MEMORANDUM

Reference: DA20/0367
To: Penrith Local Planning Panel
From: Lauren Van Etten – Development Assessment Planner
Date: 6 April 2021
Subject: Demolition of Existing Structures & Construction of Seniors Housing Development including Five (5) Self-Contained Dwellings at 8 Linksvue Avenue Leonay

This memorandum provides a response to questions from the Local Planning Panel ahead of the upcoming Local Planning Panel meeting.

erosion & sediment control

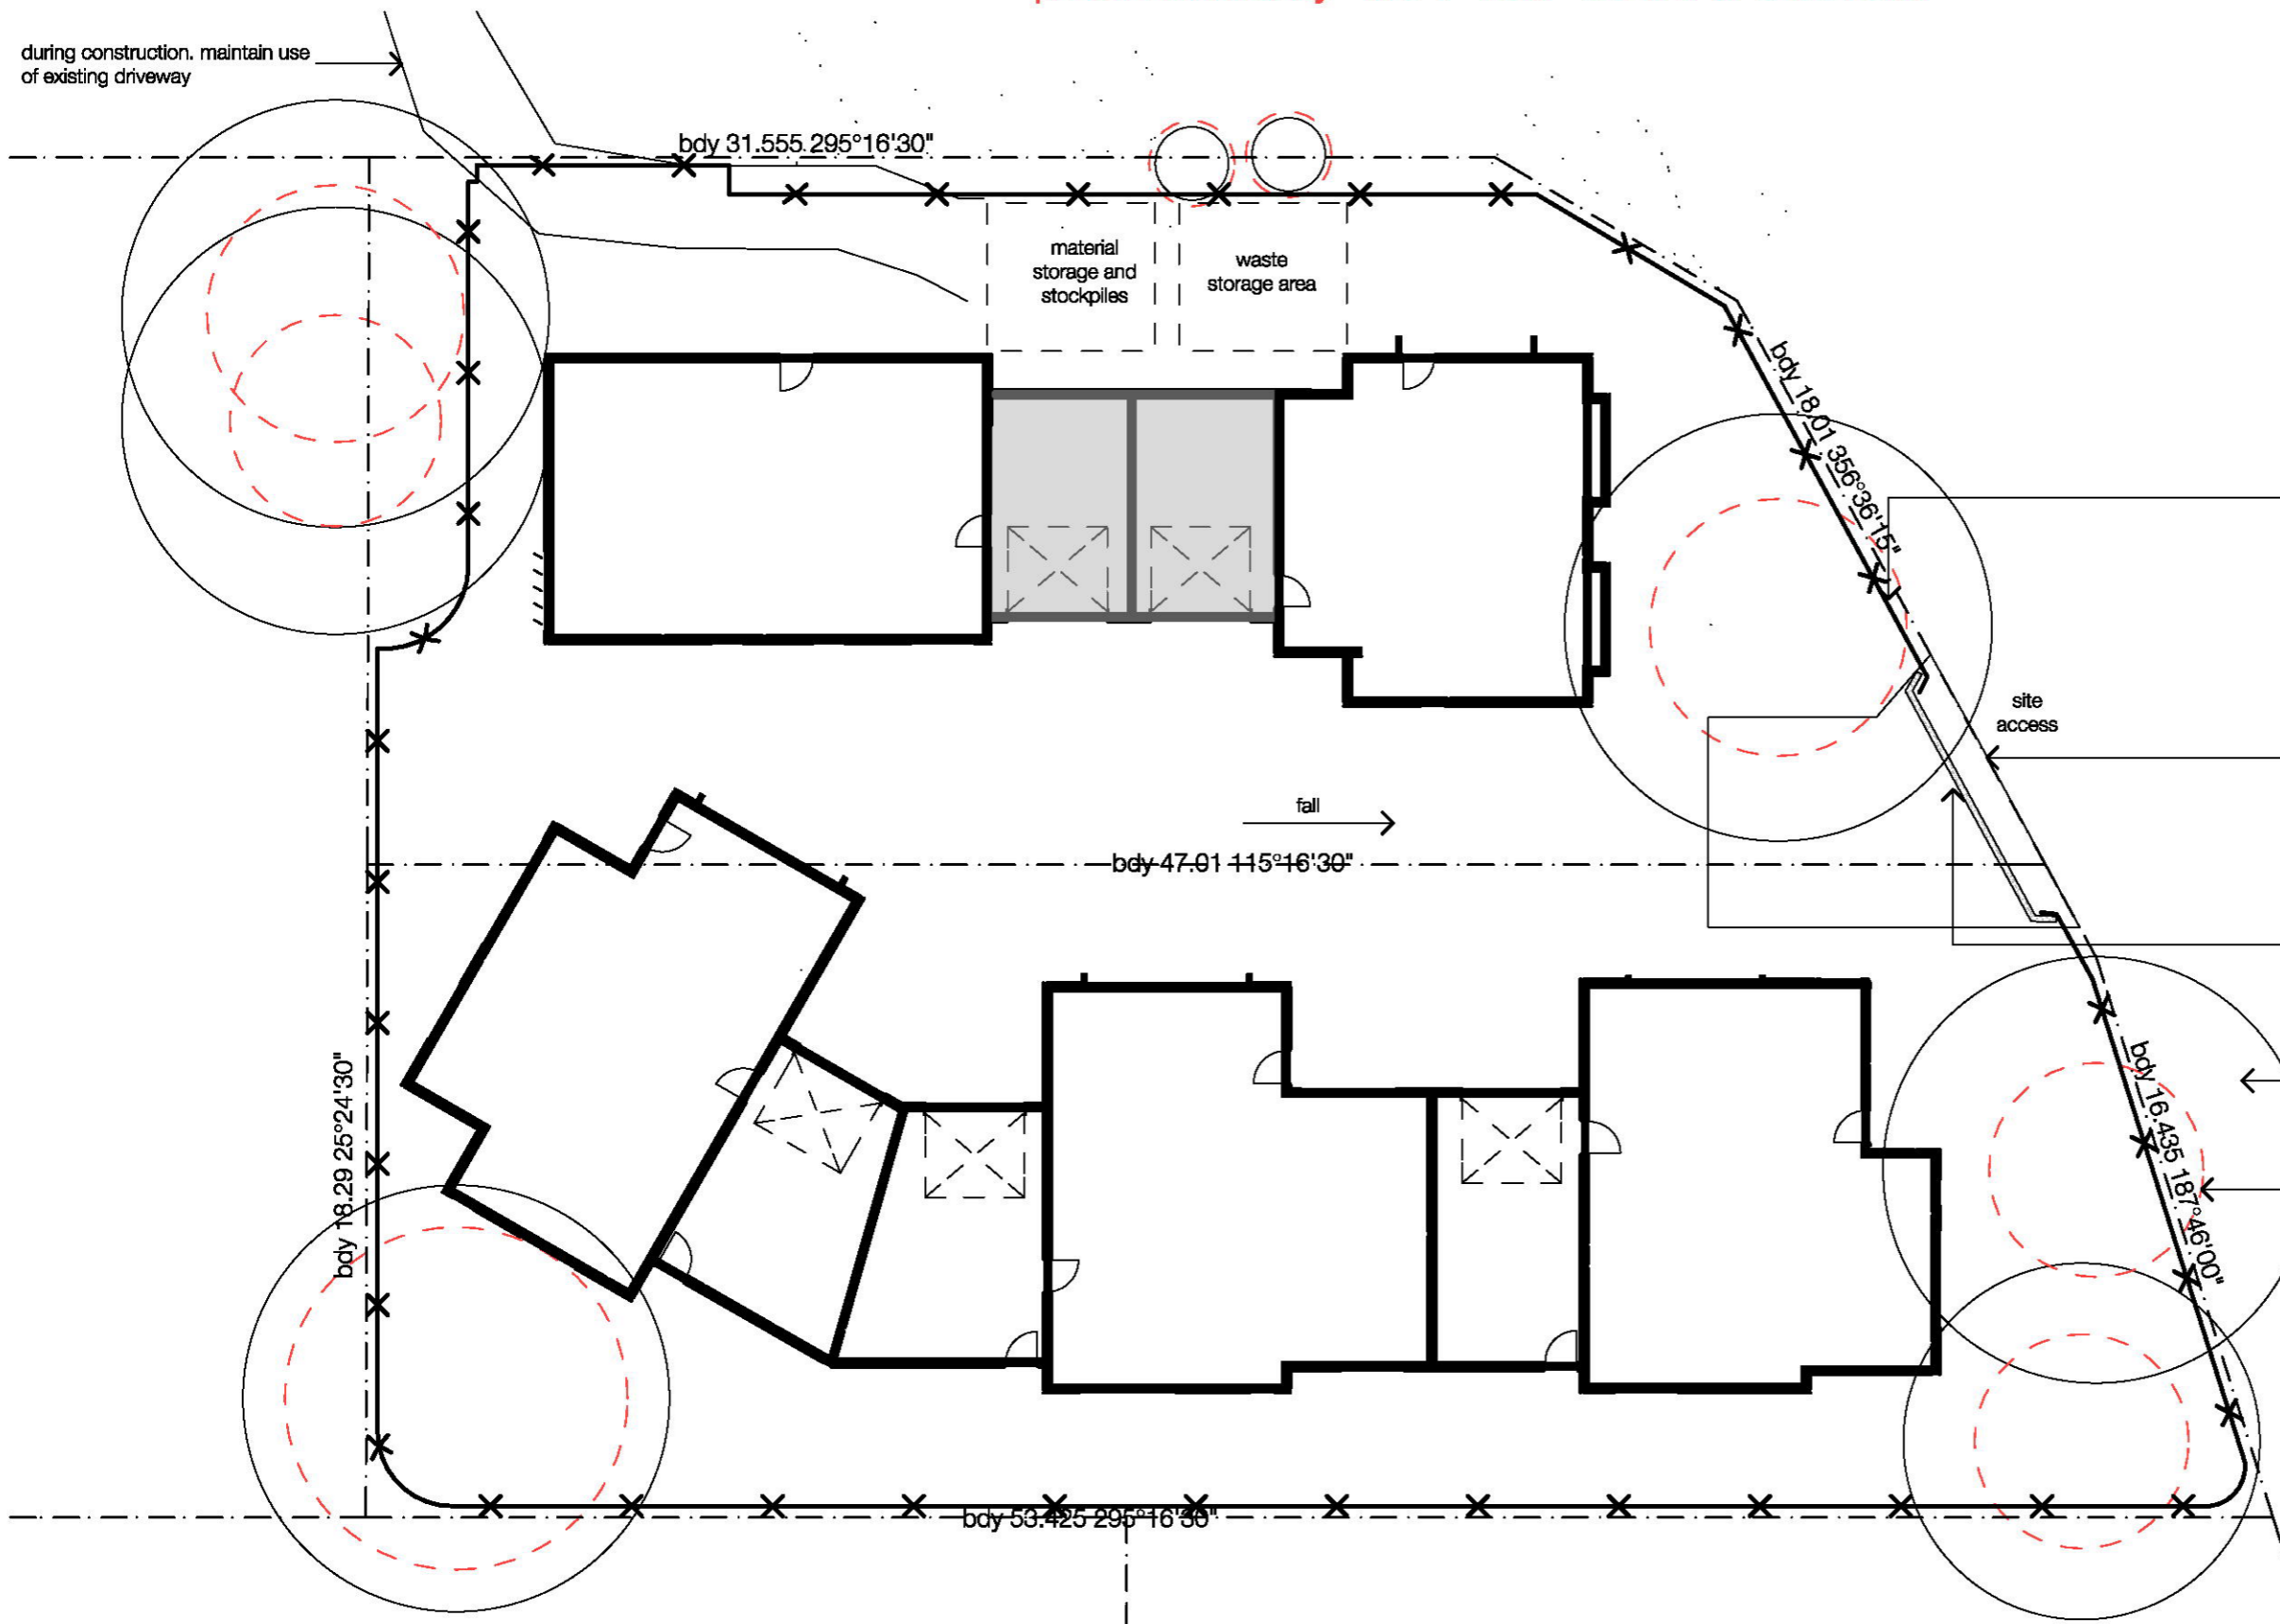
6	Recommended Amendment to Condition 1 – Additional Plans	Please find attached the demolition and erosion and sediment control plan(s) to be stamped and incorporated into Condition 1.

level 1 plan
multi-dwelling development
glenstone group | 8 linksview ave, LEONAY

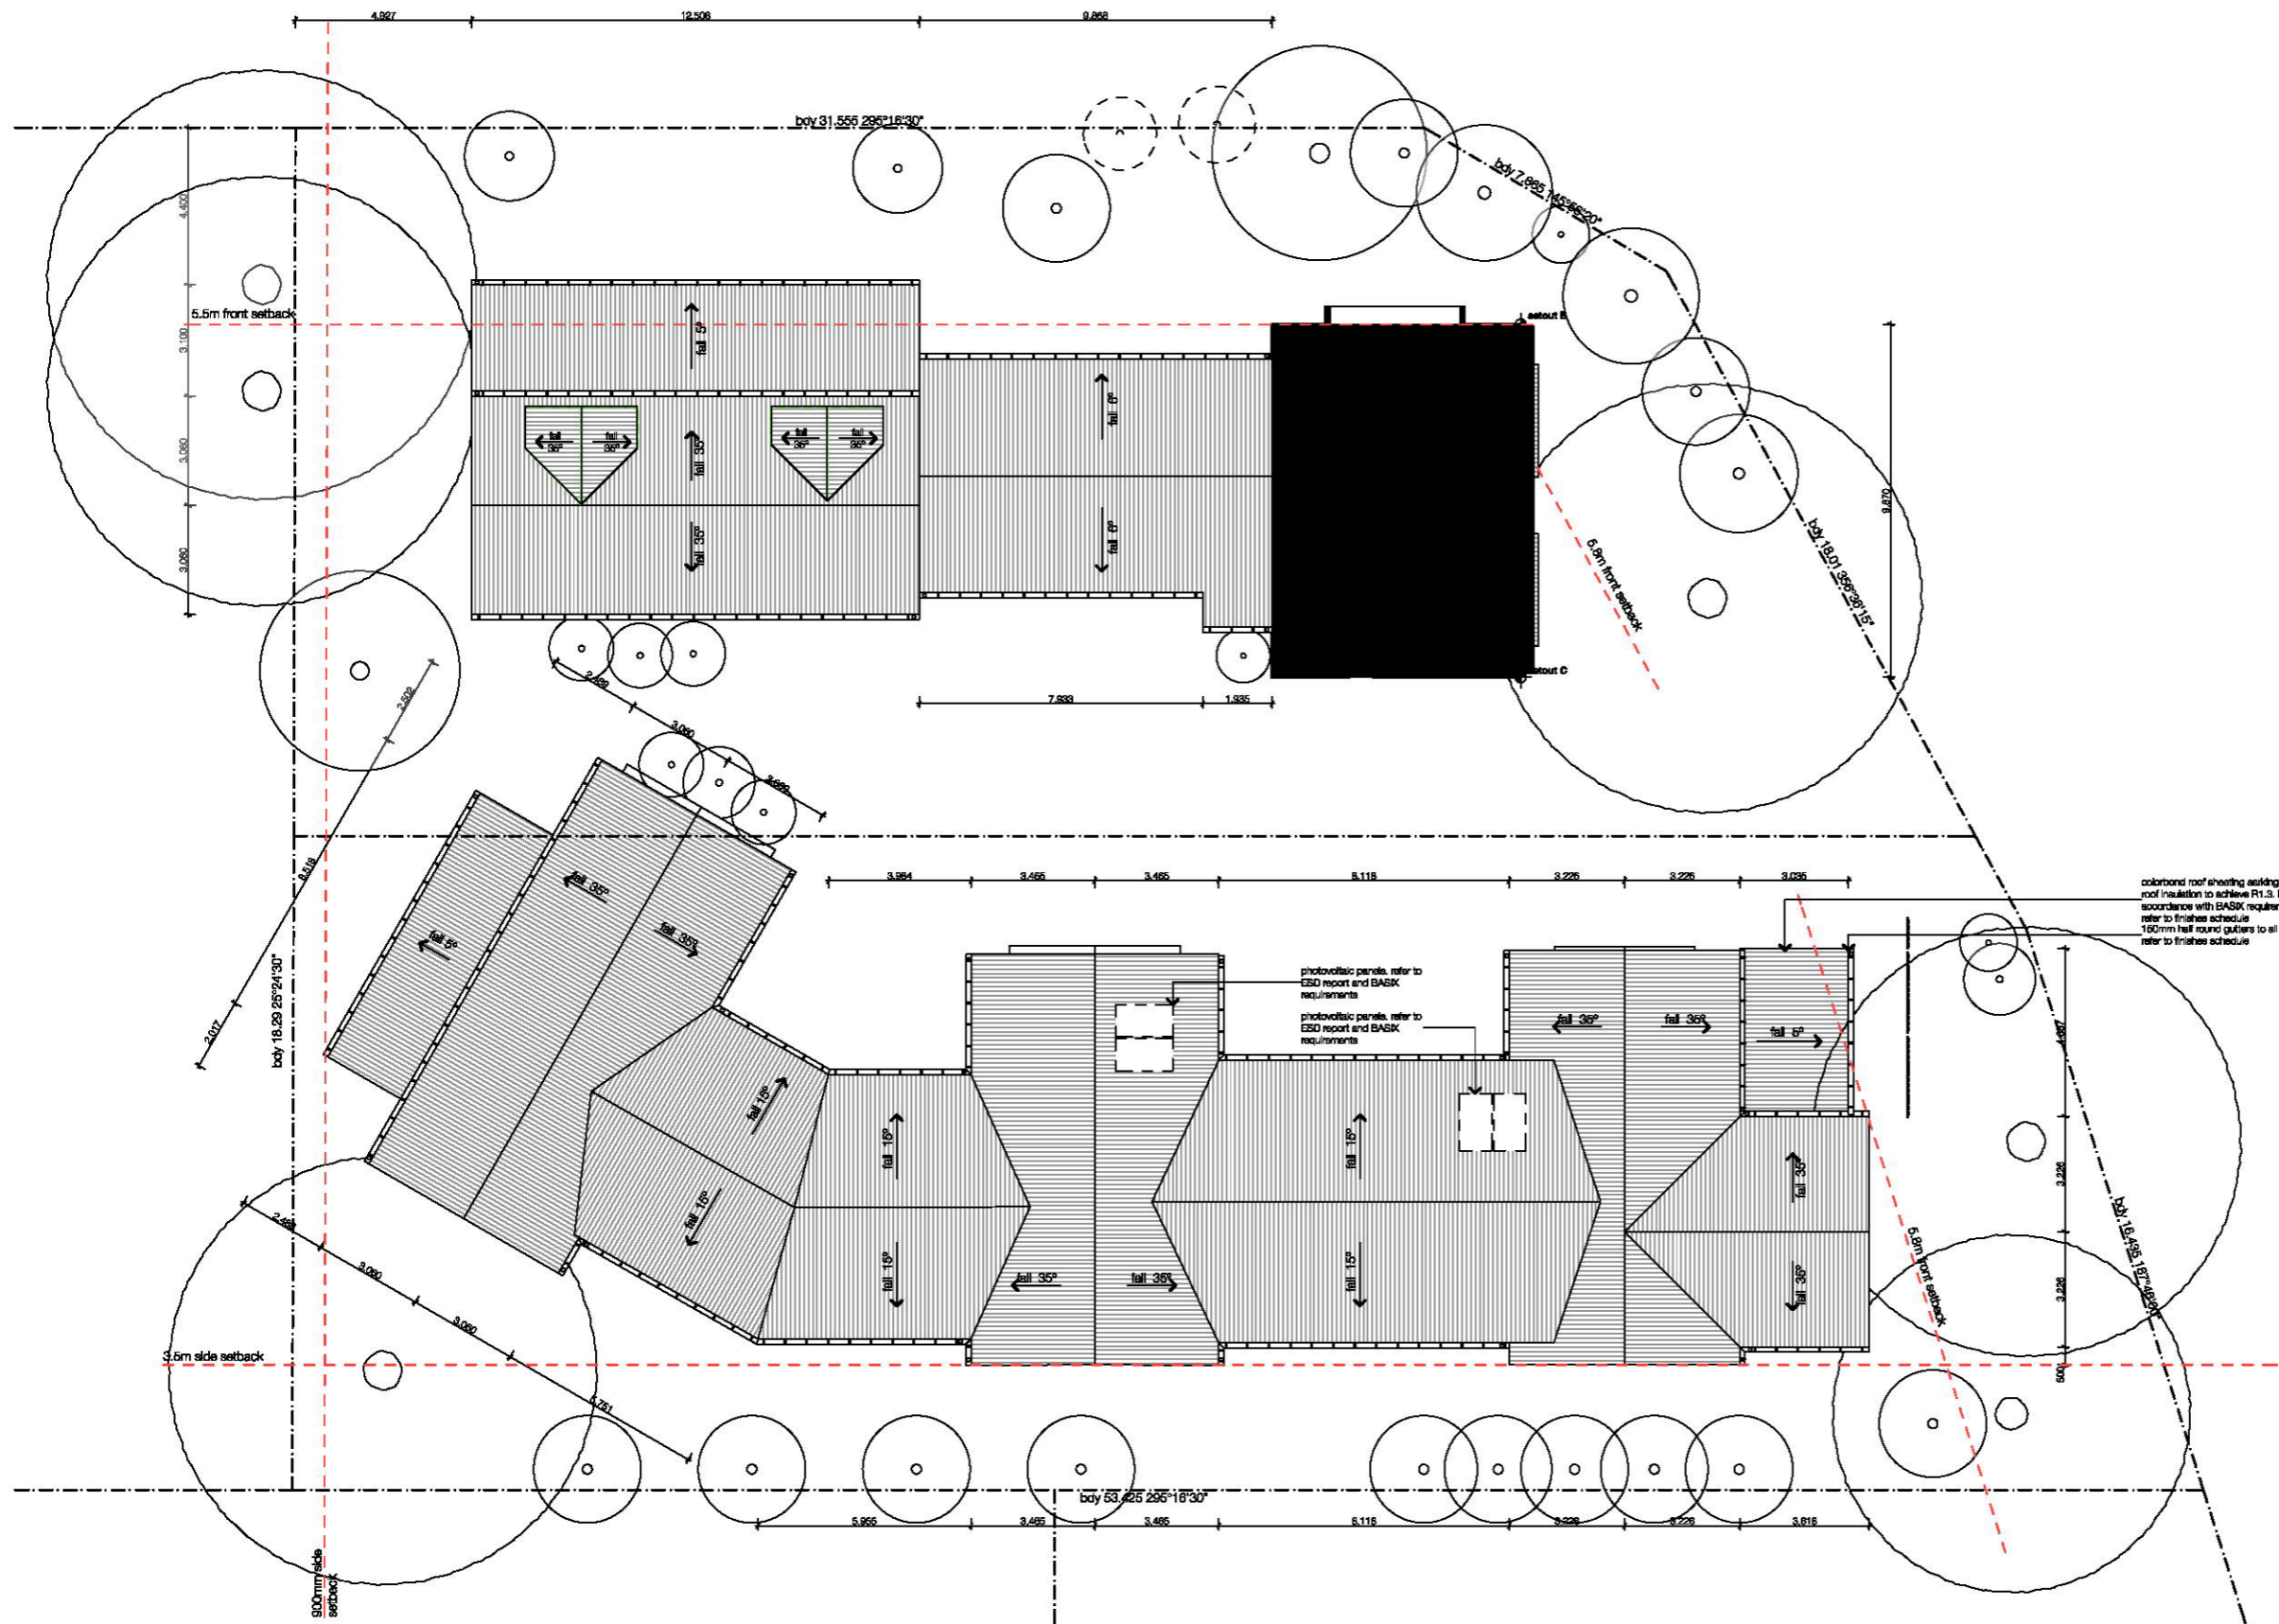
These amended conditions stem from further review by Council's Tree Management Officer.
3	Confirm no trees on adjoining sites are to be removed (the site plan indicates red circles on trees adjoining to the west – N02 and N03)	N02 and N03 are to be retained. Reference is made to the landscape plan, drawing number L1, which includes a legend identifying tree protection zones for trees to be retained.
4	Are cars able to pass when entering / exiting garage spaces to units 4 and 5	Based on the swept path within the traffic report, Council's Development Engineer confirmed that cars are not able to access the garages of units 4 and 5 simultaneously. Rather, there is space within the common driveway for one car to wait while the other manoeuvres. Council's Development Engineer raised no objections in this regard.
5	Please provide a copy of the proposed first-floor plan	Please find attached the first floor plan for Unit 2.
